{ Denotes changes to ADD. 98 - 10/15/76 CO ADD. 98 - 5/5/77

H-1 VIADUCT (WB)

INDEX TO DRAWINGS
ESTIMATED QUANTITIES

KEEHI INTERCHANGE
F.A.I. PROJ. NO. I-HI-1 (130): 17

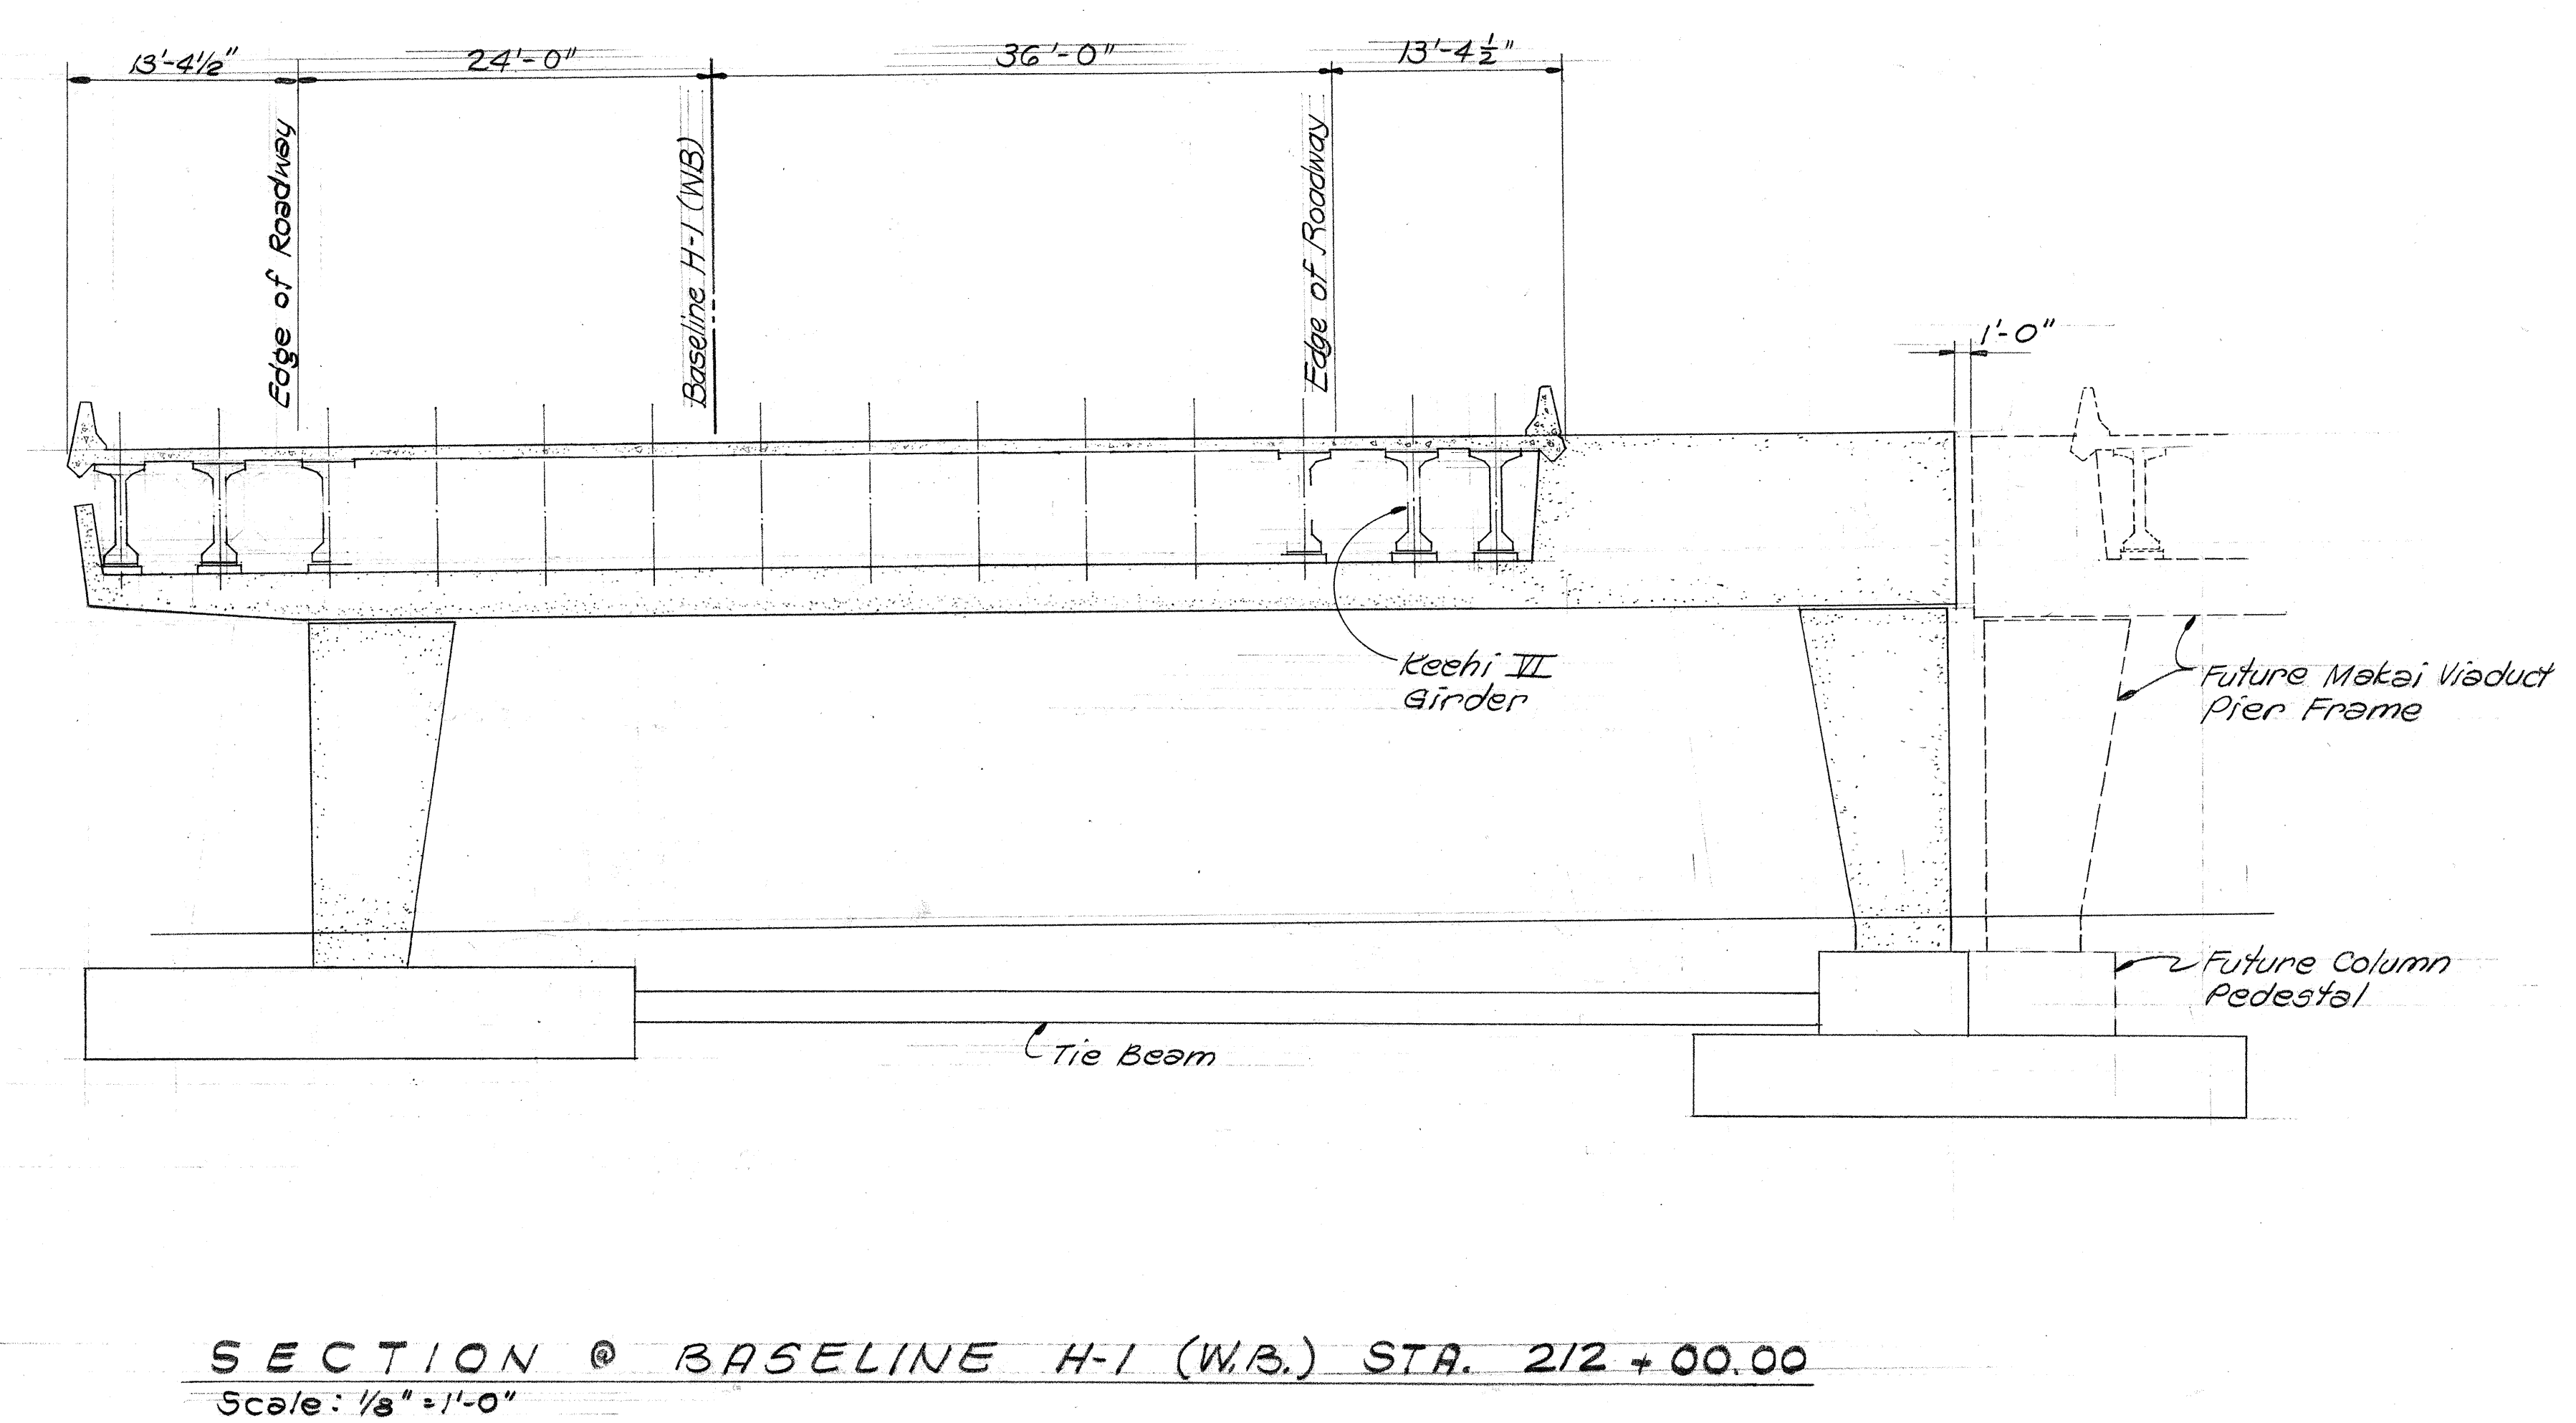
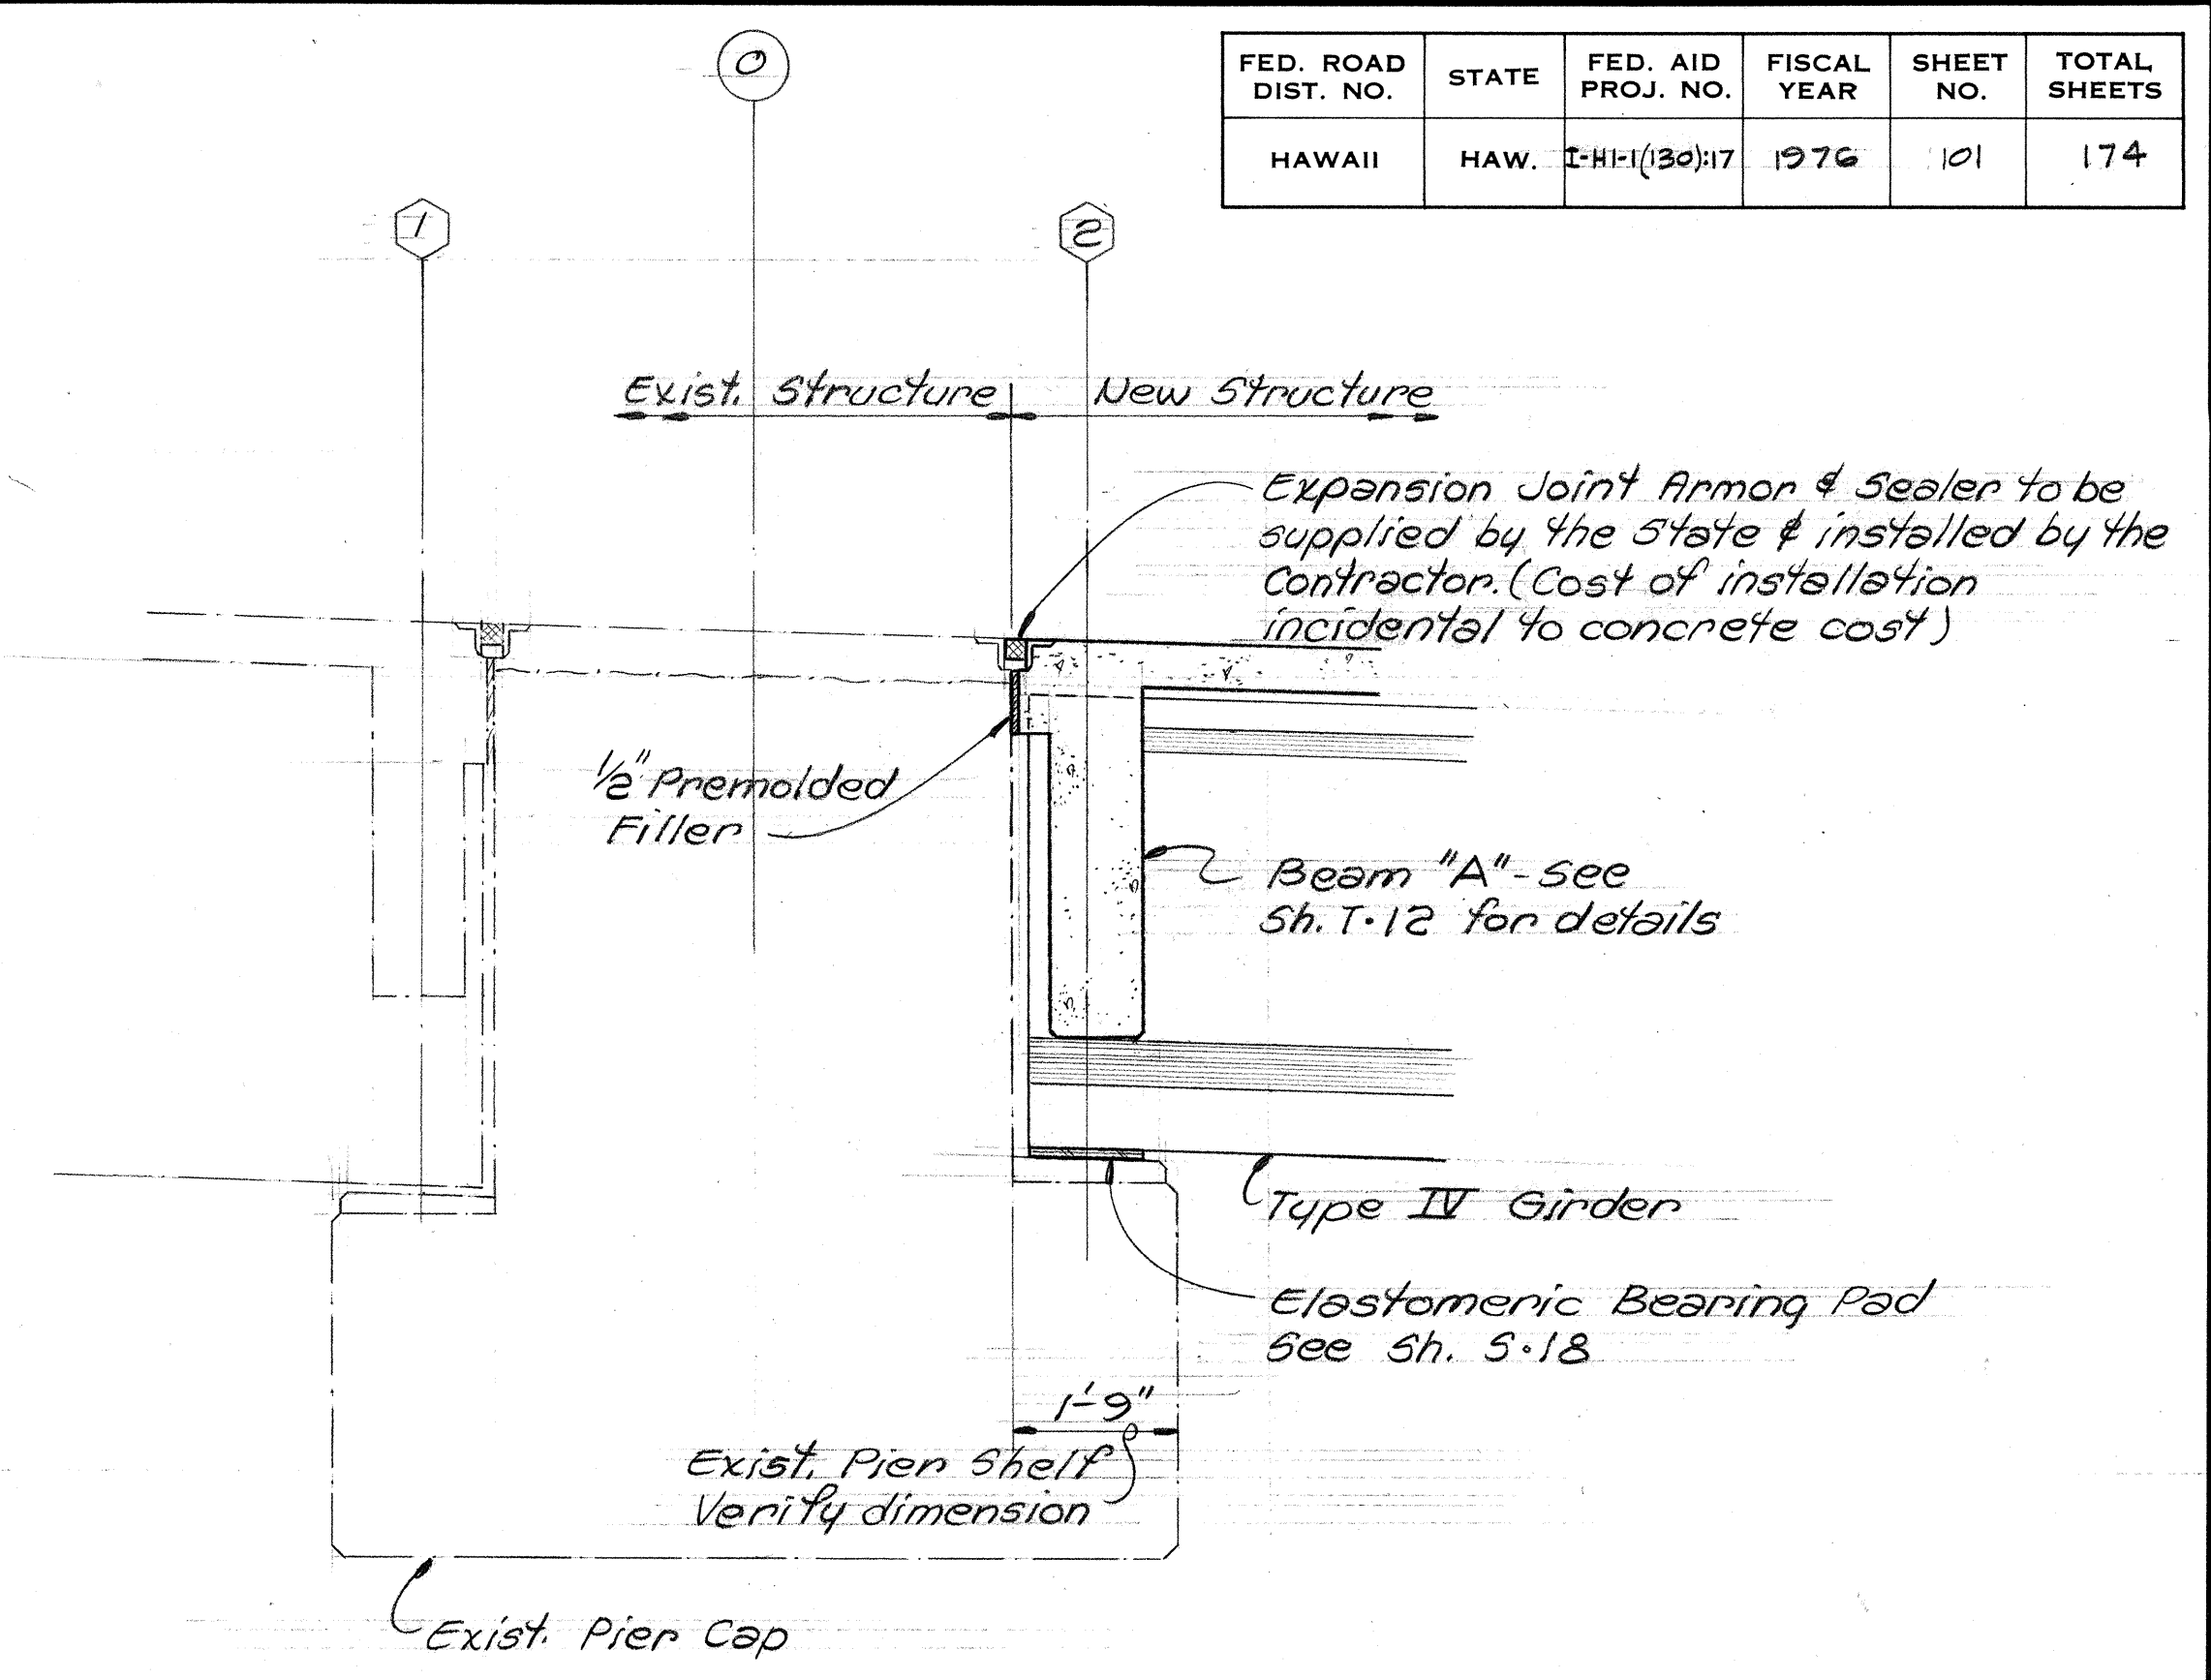
5/5/77	Revise section Sta. 210+60.00 Pier No. 1 elevation in parts and revised foundation for clarity.
DATE	REVISION
STATE OF HAWAII DEPARTMENT OF TRANSPORTATION HIGHWAYS DIVISION	
H-1 VIADUCT (WB)	
TYPICAL SECTIONS & DETAIL AT EXISTING PIER	
KEEHI INTERCHANGE F.A.I. PROJ. NO. I-H-1(130):17	
Scale: As Shown	Date: Aug. 16, 1976
SHEET NO. 3-4 OF 22 SHEETS
